Memorandum to: The West Linn Planning Commission

Re: File No. CUP-15-03/DR-15-17/VAR-15-01/02/03

Proposed Sunset Primary School Development Application

RE: File CUP-15-03/DR-15-17/VAR-15-01/02/03. New Sunset Primary School and impacts to Sunset Park and downgradient property.

Noise Sources:

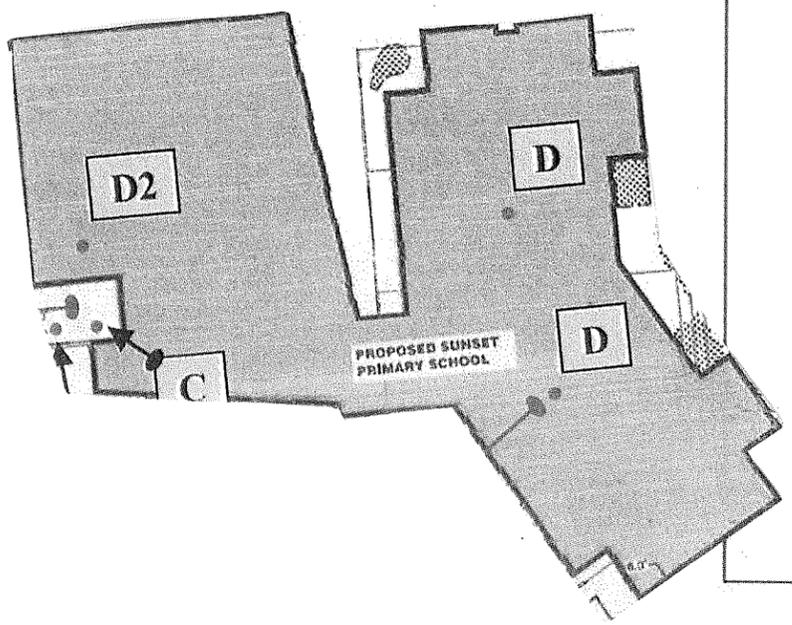
- A: PGE transformer
- B: Trash compactor
- C: Emergency generator
- D: Mechanical rooftop equipment
- D2: Heat recovery unit

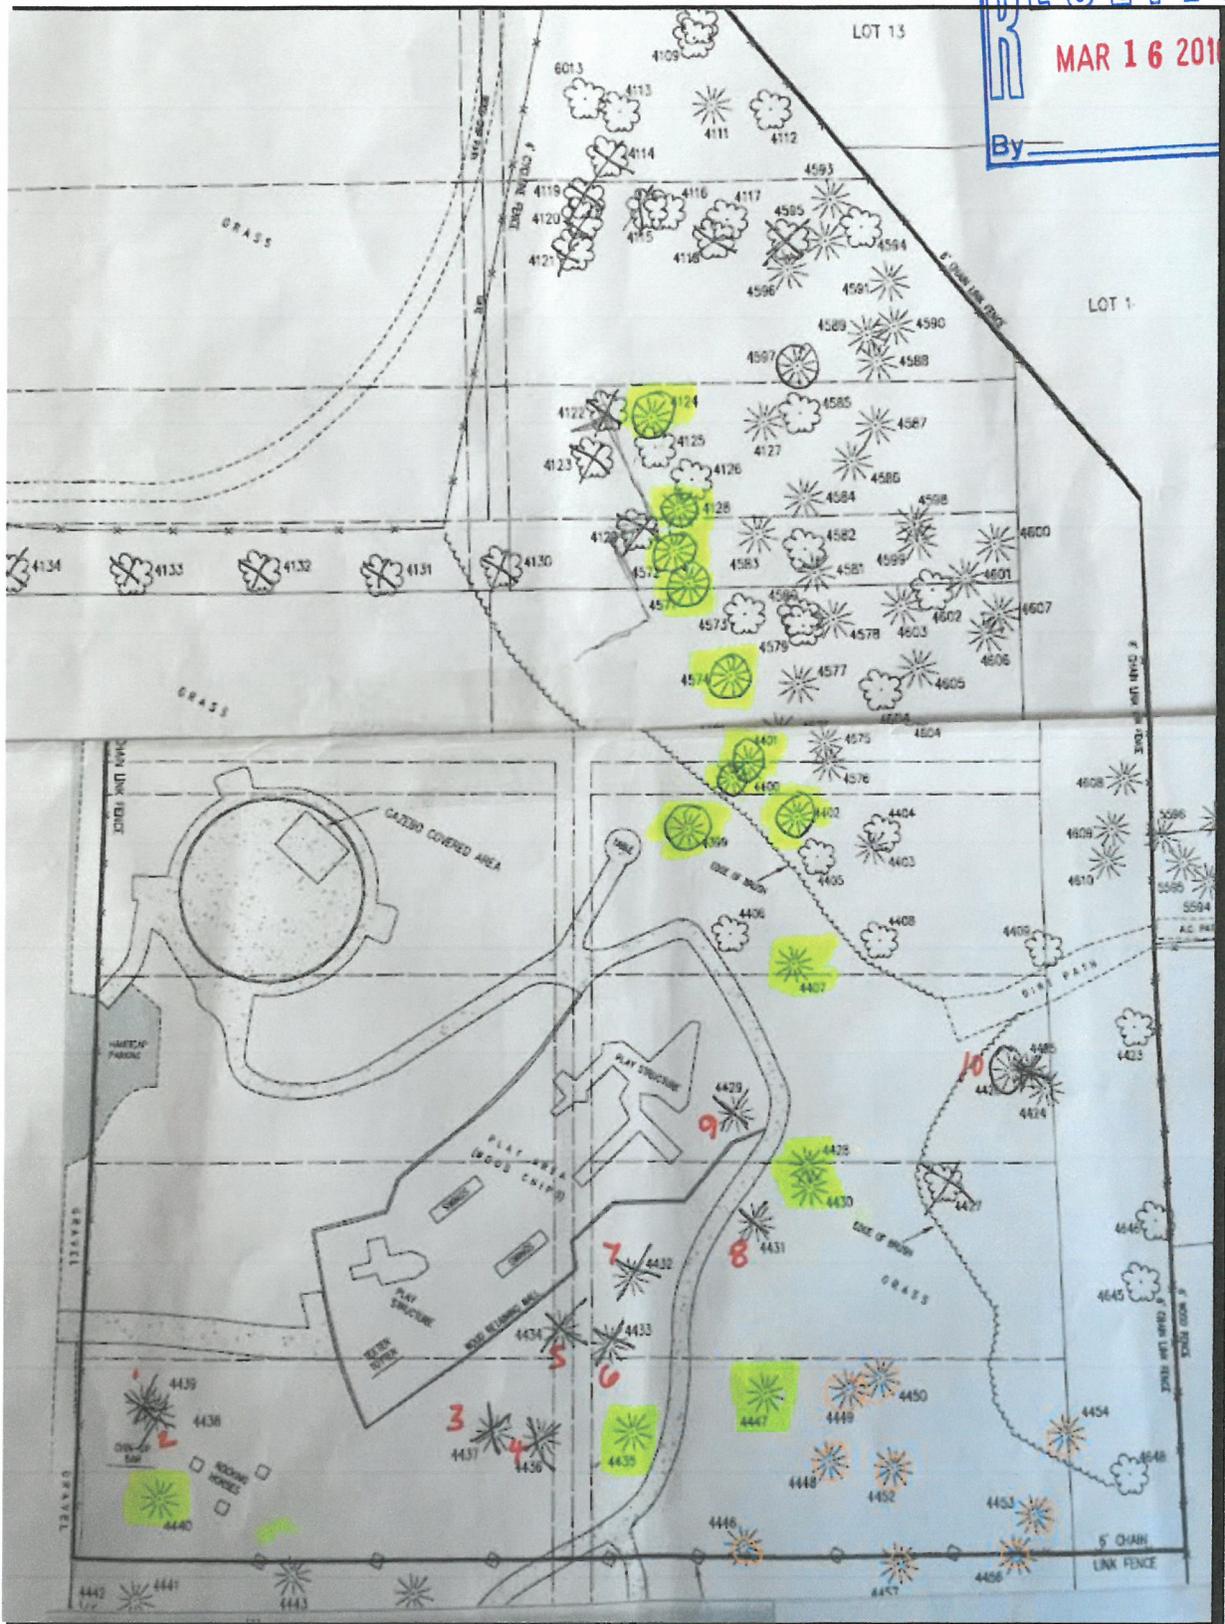
red numbered = remove for Stormwater detention pond.

Yellow = risk + need to be monitored

Orange = risk Per Hydro-Geologist

Photo 2 (left). Buttressed roots on Douglas fir (tree number 4446) in park.
Photo 3 (right). Three Douglas fir trees with buttressed roots.

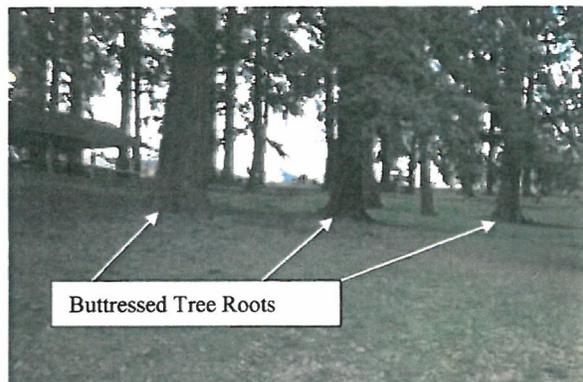
Second, many of the Douglas fir trees in the park have buttressed tree roots, which indicate steep and/or wet slopes. Wet slopes are consistent with the hydric soils shown on Figure 3.8 of the West Linn Surface Water Management Plan, 2006. These buttressed tree roots can be seen in Photo 1 above and Photos 2 and 3 below.

Photo 4. View looking south from the former wading pool towards the playground. The areas of saturated soils can be seen more easily in the playground area where storm water will try to infiltrate.

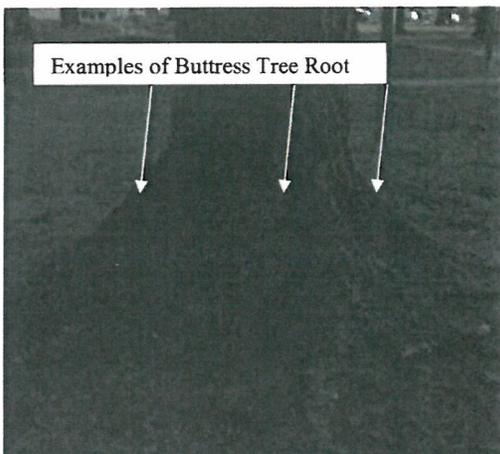
Third, just the filling of the wading pool has changed the hydrology of the site and created areas with saturated soils days after rain. Infiltrating storm water from the pond will increase the amount of saturated of soils. Photo 4 shows areas of saturated soils below the filled wading pool. Photo 5 shows a close-up the saturated soils.

Photo 5. View of saturated soils more visible in the playground area. The Douglas fir trees below the playground have buttressed roots.

Figure 1. Site Location Map and Shallow Landslide Risk

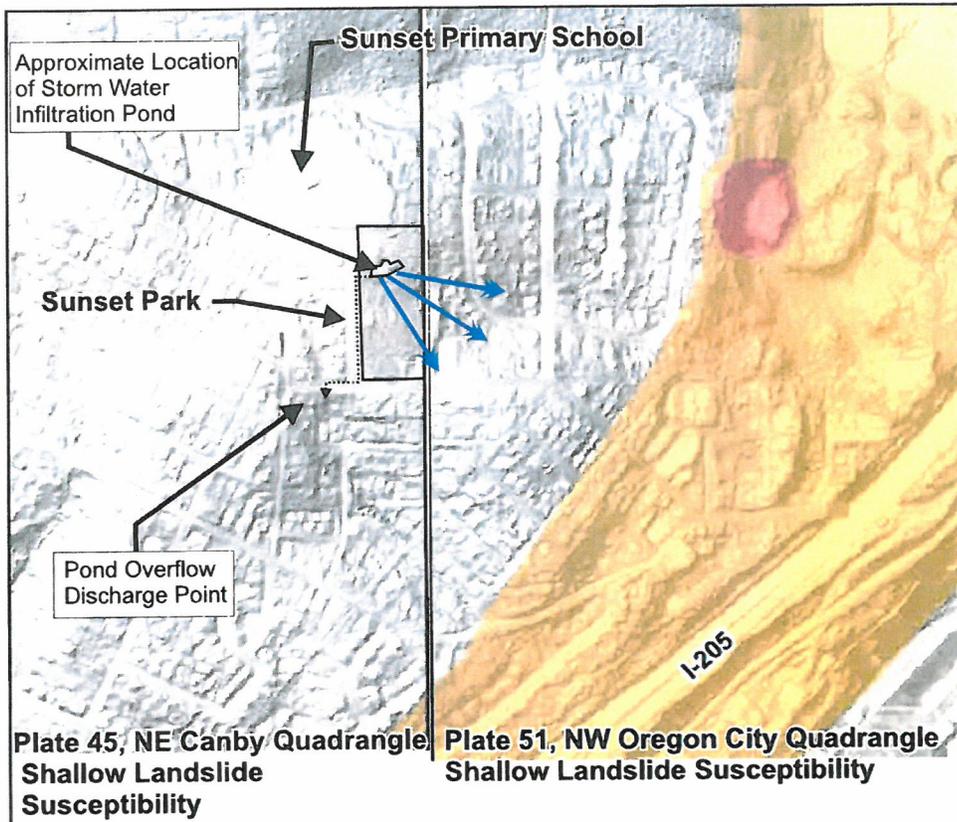
- Existing shallow landslide areas will be more susceptible to reactivation. See Figures 1 and 2 and section titled "Shallow and Deep Landslide Potential" for additional discussion of landslides.
